## Firmware 2.06.3 bug list:

## List of bugs/improvement requests

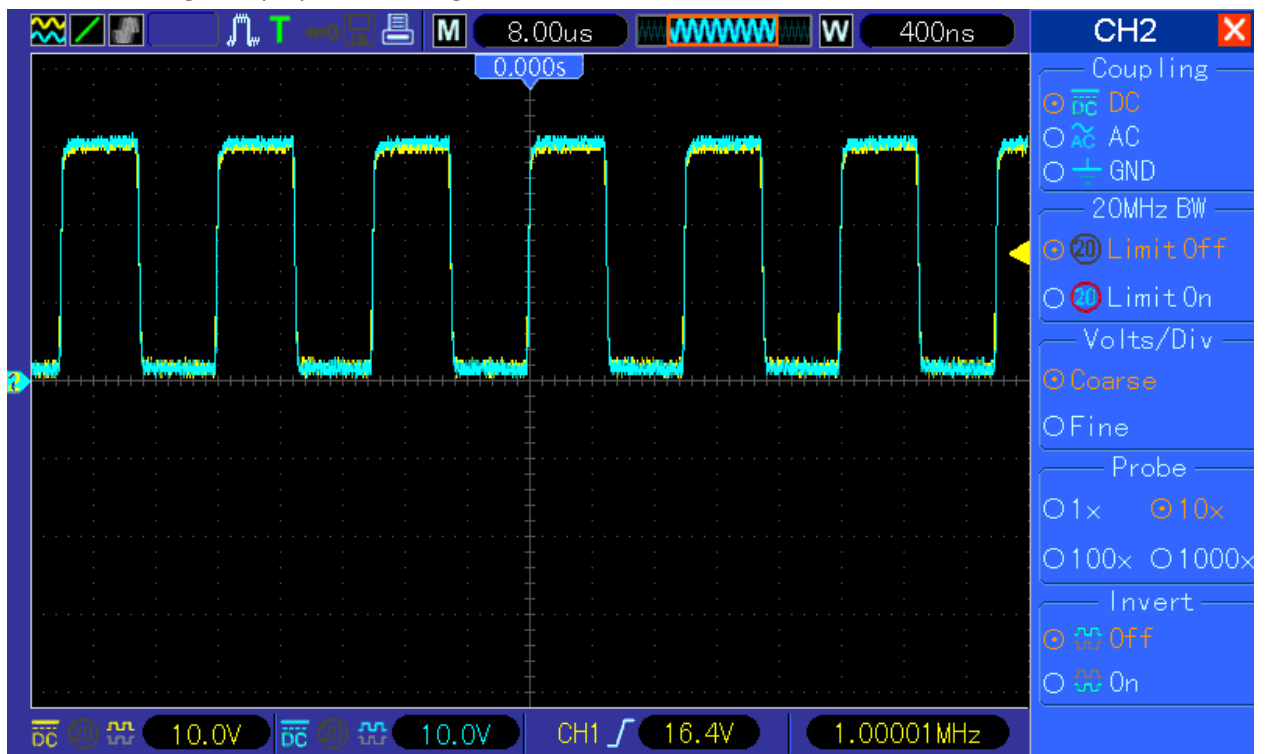
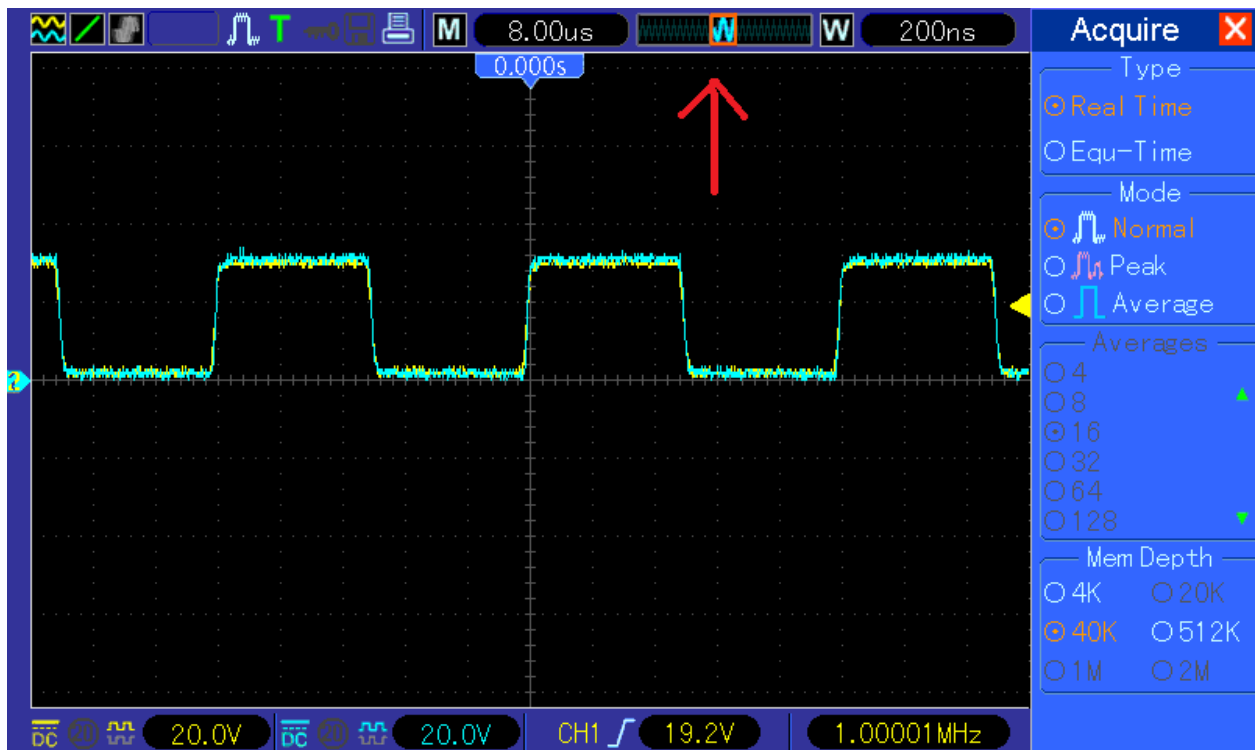
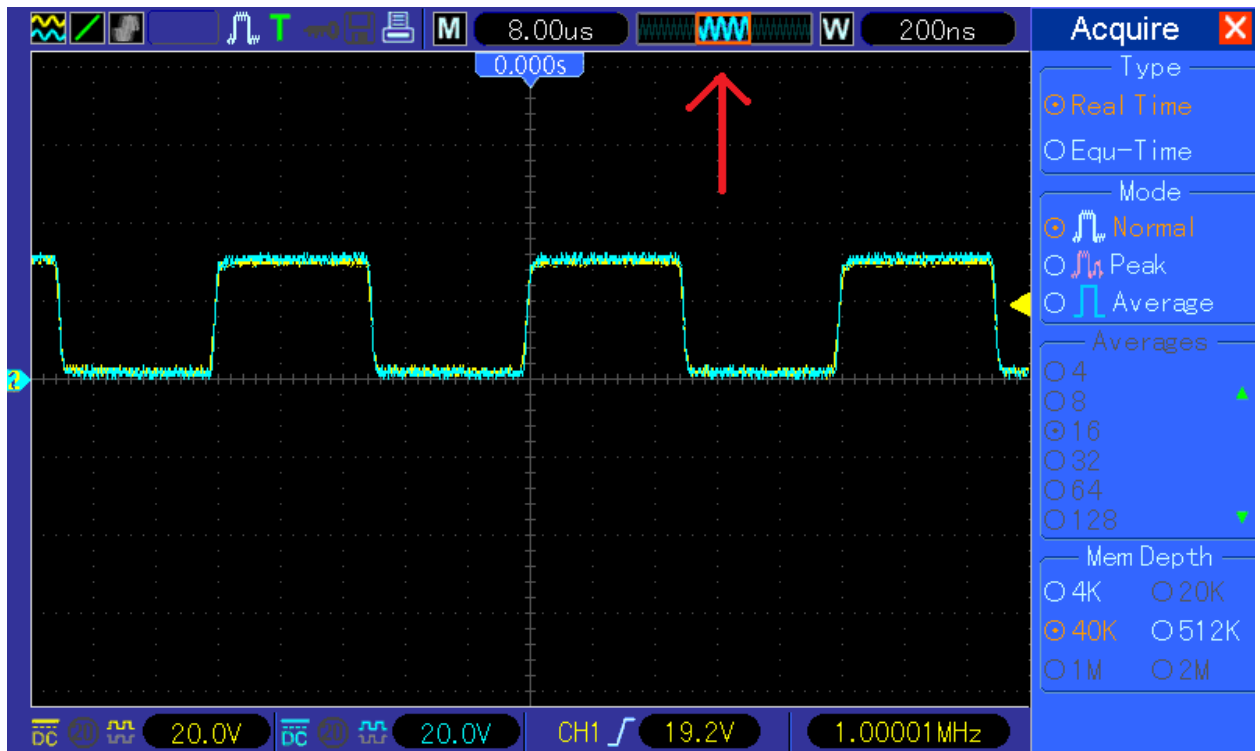
37. With Long Memory enabled (40k, 512k, 1M, 2M?) when the WTB is 400ns/DIV (and lower, up to 2ns/DIV) when enabling second channel the indicator in status line will be already displayed but the waveform is missing. Additionally the CH2 LED is off :

But after changing Timebase (or wave position) one position forth and back the second channel waveform will get displayed and LED gets on :

35. Not a bug – but really annoying thing.
36. Not a bug, but who need to see trailing zeros?
37. Turn Timebase knob one position forth and back.
38. This is funny bug, isn’t?

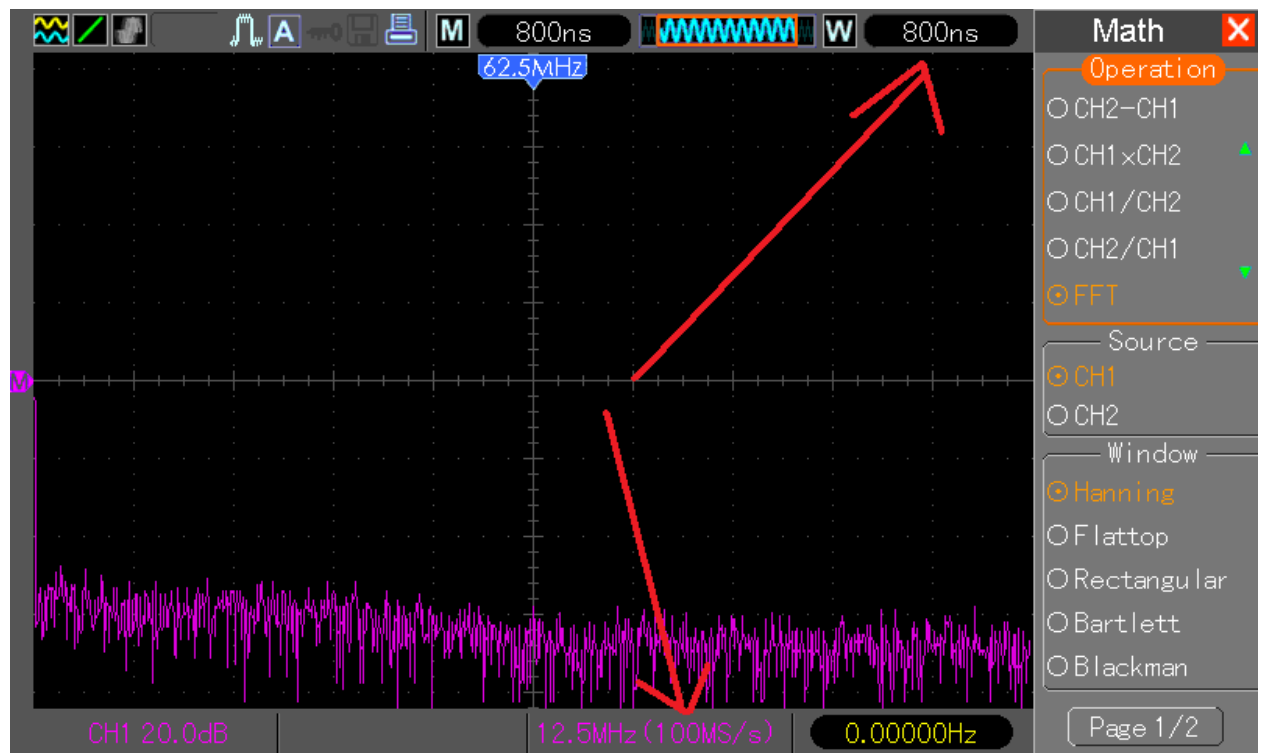
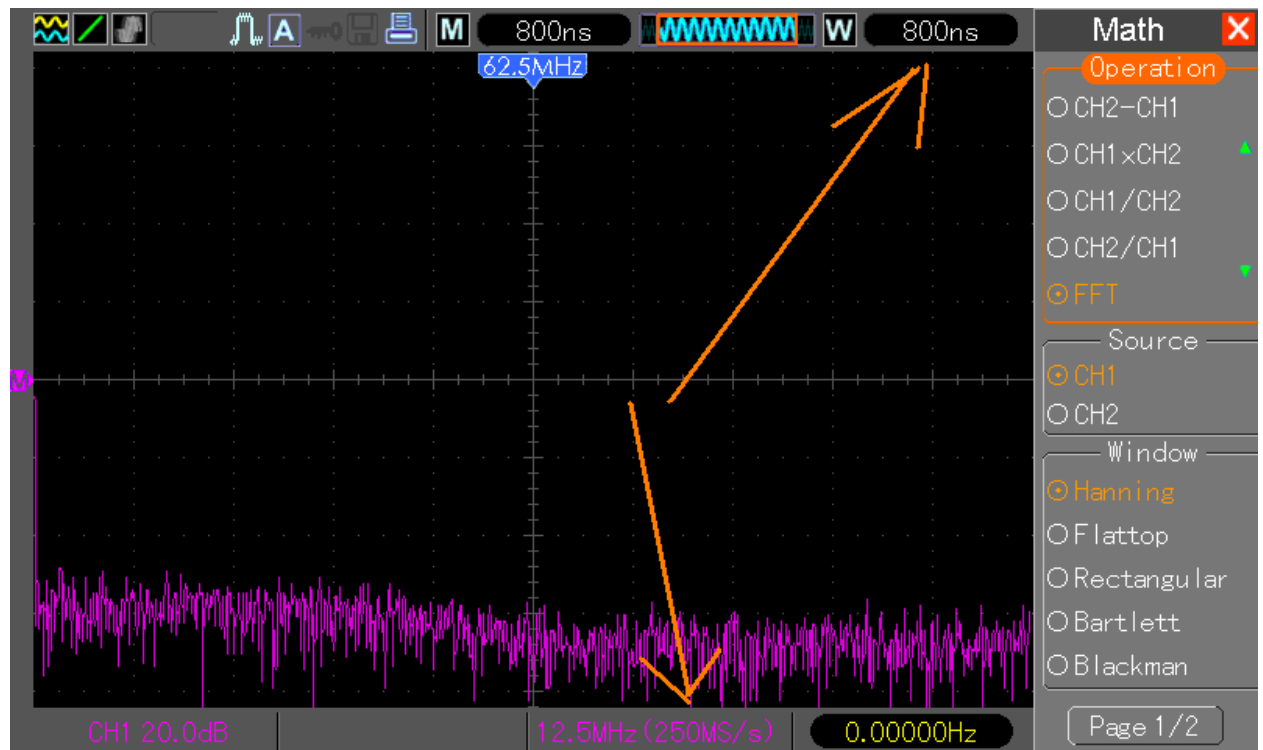
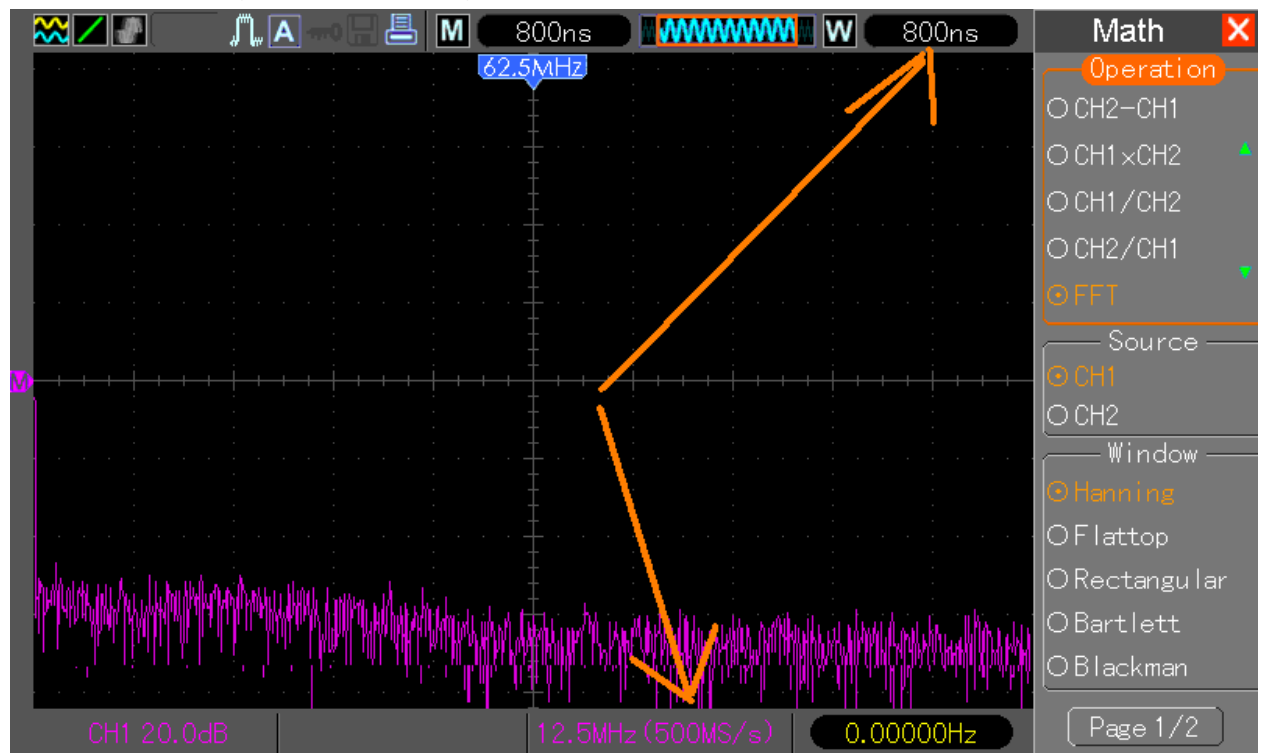
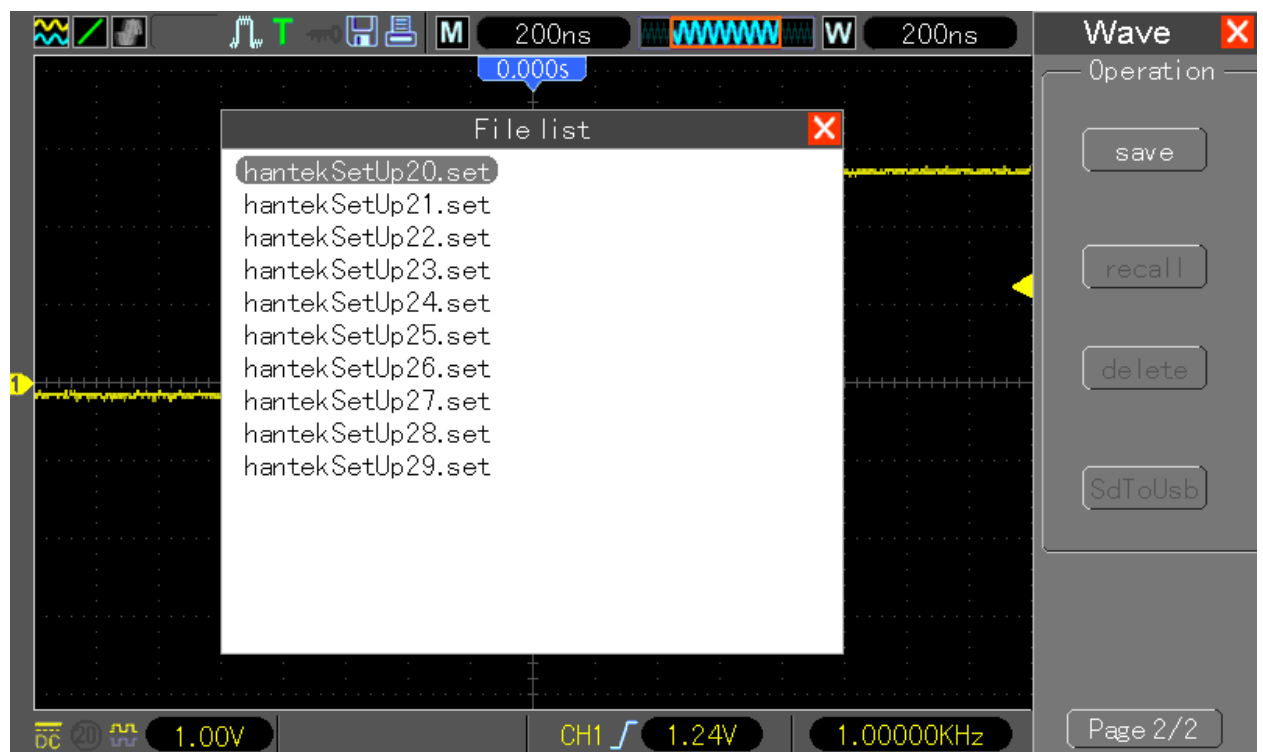
39. Within FFT the information in status bar is not always showing the proper sampling rate, sometimes even jumping from proper to bad value. As the FFT cursor is taking in count the sampling rate, the measure value might be not correct. Example random values in 800ns/DIV

FFT , here 100MS/s

then 250MS/s (but still 800ns/DIV)

and here 500MS/s (but still 800ns/DIV)

- 39. Turn Timebase know one position forth and back, in most cases the Sampling Rate within FFT will be then updated to proper value.
- 40. ~~Ensure that no more than 10 file on the Flash Drive.~~
- 41. ~~No fix for this~~
- 42. ~~Nothing to say here.~~
- 43. ~~Nothing to say here.~~
- 44. ~~Nothing to say here.~~
- 45. ~~Nothing to say here.~~
- 46. ~~Nothing to say here.~~
- 47. When measuring waveform(s) use the tracking cursor only in main window. In wave/FFT mode it does works properly.
- 48. ~~Nothing to say here.~~
- 49. Simply ignore 5% of the right data/display region (when you look on display, the data near menu)
